RESPONSE TO THE CONSULTANT'S DESIGN REVIEW COMMENTS						DATE		23.03, 2025				
PROJECT NAME: The Project of the New Port of Caio in Cabinda												
MAIN SUBJECT: RESPONSE TO CONSULTANT'S DESIGN REVIEW COMMENTS RAD-CRBC-135 DD PERSONAL GATE_SE20250314 (ARCH PART)						SECTION OF PROJECT		LOT 1 LOT 2 LOT 3 OTHER <input checked="" type="checkbox"/> <input type="checkbox"/> <input type="checkbox"/> <input type="checkbox"/>				
ROAD NETWORK	CIVIL	FIRE PROTECTION	ELECTRICAL	INSTRUMENT	STRUCTURAL	MECHANICAL PROCESS	HVAC	PLUMBING	GEOTECHNICAL	ESTIMATING	PROJECT	OTHER
<input type="checkbox"/>	<input type="checkbox"/>	<input type="checkbox"/>	<input checked="" type="checkbox"/>	<input type="checkbox"/>	<input checked="" type="checkbox"/>	<input type="checkbox"/>	<input checked="" type="checkbox"/>	<input checked="" type="checkbox"/>	<input type="checkbox"/>	<input type="checkbox"/>	<input type="checkbox"/>	<input type="checkbox"/>

PREPARED BY: DESIGN TEAM OF CRBC CAIOPORT PROJECT MANAGEMENT						REVIEW DOCUMENT REF. & DATE OF THE CONSULTANT		RAD-CRBC-135 DD PERSONAL GATE_SE20250314 (ARCH PART)				
REVIEWER BY: Gao Changsheng / CHIEF ENGINEER OF CRBC CAIOPORT PROJECT MANAGEMENT						CONT

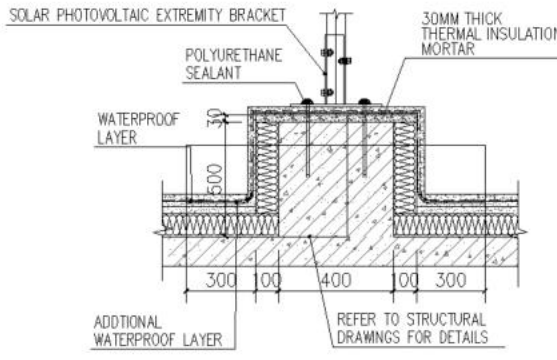
<p>Response: Accepted. It has been revised.</p>					
	<div>LOT1_DD_1021-A-03</div>	<p>add supplementary relevant sections</p> <p>Response: Accepted. It has been added.</p> <p>add threshold details</p> <p>Response: Accepted. It has been added.</p> <table><tr><th>DETAILS FOR ENTRANCE THRESHOLD</th><th>DETAILS FOR TOILET THRESHOLD</th></tr><tr><td><p>12MM THICK CERAMIC ANTI-SLIP TILE, 1:1 CEMENT PASTE POINTING 20MM THICK 1:3 CEMENT MORTAR 150MM THICK C35/45 REINFORCED CONCRETE (R10-200) 100MM THICK C12/15 CONCRETE PLAIN SOIL COMPACTION</p><p>INSIDE 200 100 DOORSTONE OUTSIDE -0.020</p><p>0.4MM THICK POLYETHYLENE FILM</p><p>MUS CONCRETE HOLLOW BRICK (CONCRETE FILLING C20/25)</p><p>EXPANDED POLYSTYRENE GASKET</p><p>12 1:10</p></td><td><p>12MM THICK CERAMIC ANTI-SLIP TILE, 1:1 CEMENT PASTE POINTING 20MM THICK 1:3 CEMENT MORTAR 150MM THICK C35/45 REINFORCED CONCRETE (R10-200) 100MM THICK C12/15 CONCRETE PLAIN SOIL COMPACTION</p><p>GUARD'S ROOM 200 DOORSTONE TOILET -0.020</p><p>0.4MM THICK POLYETHYLENE FILM</p><p>MUS CONCRETE HOLLOW BRICK (CONCRETE FILLING C20/25)</p><p>EXPANDED POLYSTYRENE GASKET</p><p>13 1:10</p></td></tr></table> <p>- recheck the slopes as it can't work together for having the designed ramps</p> <p>- check the ramp requirements for disability access</p> <p>Response: Accepted. It has been revised. Modify the elevation of the entrance. The slope of the ramp should be 6%, meeting the requirements for disability access.</p>	DETAILS FOR ENTRANCE THRESHOLD	DETAILS FOR TOILET THRESHOLD	<p>12MM THICK CERAMIC ANTI-SLIP TILE, 1:1 CEMENT PASTE POINTING 20MM THICK 1:3 CEMENT MORTAR 150MM THICK C35/45 REINFORCED CONCRETE (R10-200) 100MM THICK C12/15 CONCRETE PLAIN SOIL COMPACTION</p> <p>INSIDE 200 100 DOORSTONE OUTSIDE -0.020</p> <p>0.4MM THICK POLYETHYLENE FILM</p> <p>MUS CONCRETE HOLLOW BRICK (CONCRETE FILLING C20/25)</p> <p>EXPANDED POLYSTYRENE GASKET</p> <p>12 1:10</p>	<p>12MM THICK CERAMIC ANTI-SLIP TILE, 1:1 CEMENT PASTE POINTING 20MM THICK 1:3 CEMENT MORTAR 150MM THICK C35/45 REINFORCED CONCRETE (R10-200) 100MM THICK C12/15 CONCRETE PLAIN SOIL COMPACTION</p> <p>GUARD'S ROOM 200 DOORSTONE TOILET -0.020</p> <p>0.4MM THICK POLYETHYLENE FILM</p> <p>MUS CONCRETE HOLLOW BRICK (CONCRETE FILLING C20/25)</p> <p>EXPANDED POLYSTYRENE GASKET</p> <p>13 1:10</p>	A
DETAILS FOR ENTRANCE THRESHOLD	DETAILS FOR TOILET THRESHOLD						
<p>12MM THICK CERAMIC ANTI-SLIP TILE, 1:1 CEMENT PASTE POINTING 20MM THICK 1:3 CEMENT MORTAR 150MM THICK C35/45 REINFORCED CONCRETE (R10-200) 100MM THICK C12/15 CONCRETE PLAIN SOIL COMPACTION</p> <p>INSIDE 200 100 DOORSTONE OUTSIDE -0.020</p> <p>0.4MM THICK POLYETHYLENE FILM</p> <p>MUS CONCRETE HOLLOW BRICK (CONCRETE FILLING C20/25)</p> <p>EXPANDED POLYSTYRENE GASKET</p> <p>12 1:10</p>	<p>12MM THICK CERAMIC ANTI-SLIP TILE, 1:1 CEMENT PASTE POINTING 20MM THICK 1:3 CEMENT MORTAR 150MM THICK C35/45 REINFORCED CONCRETE (R10-200) 100MM THICK C12/15 CONCRETE PLAIN SOIL COMPACTION</p> <p>GUARD'S ROOM 200 DOORSTONE TOILET -0.020</p> <p>0.4MM THICK POLYETHYLENE FILM</p> <p>MUS CONCRETE HOLLOW BRICK (CONCRETE FILLING C20/25)</p> <p>EXPANDED POLYSTYRENE GASKET</p> <p>13 1:10</p>						
	<div>LOT1_DD_1021-A-04</div>	<p>1. - no dimensions and elevations for setting up the screeding</p> <p>Response: Accepted. Dimensions and elevations have been added.</p> <p>2. - details for penetrations missing; penetrations has to be confirmed on the structural design</p> <p>Response: Accepted. Details have been added.</p> <p>- details of equipment supports missing</p> <p>Response: Accepted. Details have been added.</p> <p>3. -no dimensions and elevations for setting up the screeding</p> <p>Response: Accepted. Dimensions and elevations have been added.</p> <p>4. detail for photovoltaic system supports are missing</p> <p>Response: Accepted. Details have been added.</p>	A

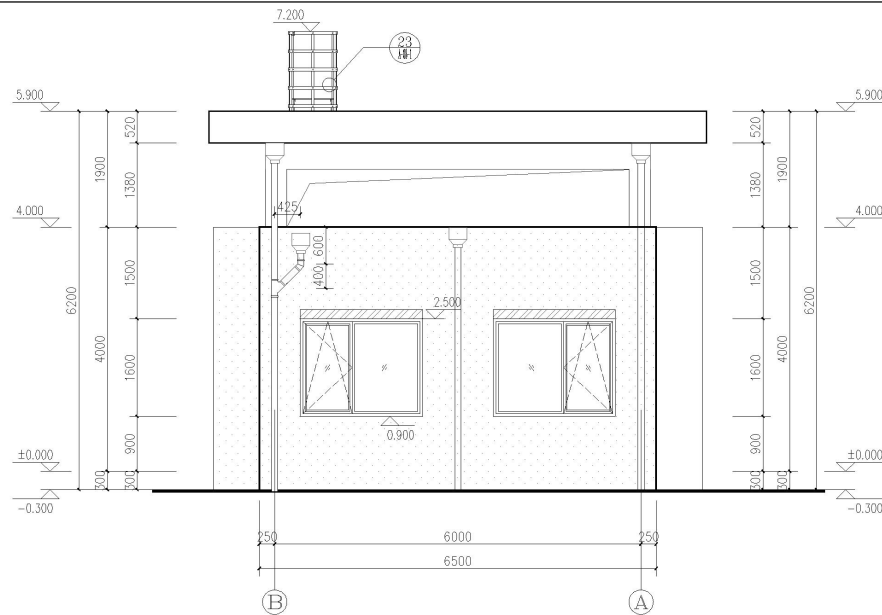
2. - add proper detail and coordinate with plumbing design - refer to LOT1_DD_1021-P-04 and LOT1_DD_1021-P-05

Response: Accepted. It has been coordinate with plumbing design and has been revised.

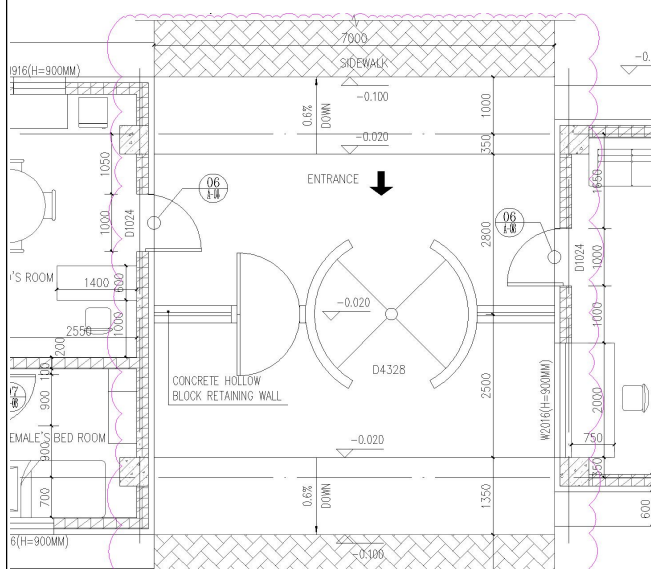
3. roof is exposed on 3 sides - not acceptable for the rain water from the roof to dripdown on the facade unto walkway - add parapet and collect it through the rainwater system; adjust the slopes accordingly

Response: Accepted. It has been revised, add parapets and downspouts to implement organized drainage.

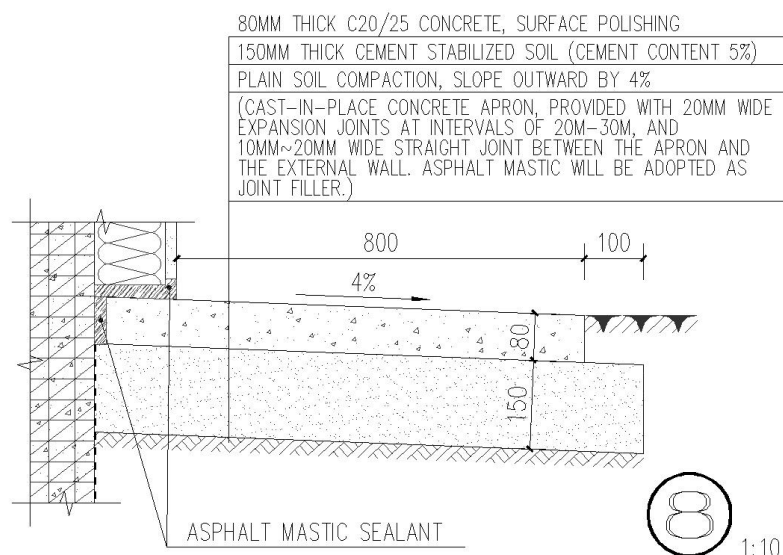
6. missing details of the turnstile

Response: Accepted. Add the turnstils details LOT1_DD_1021-A-09.
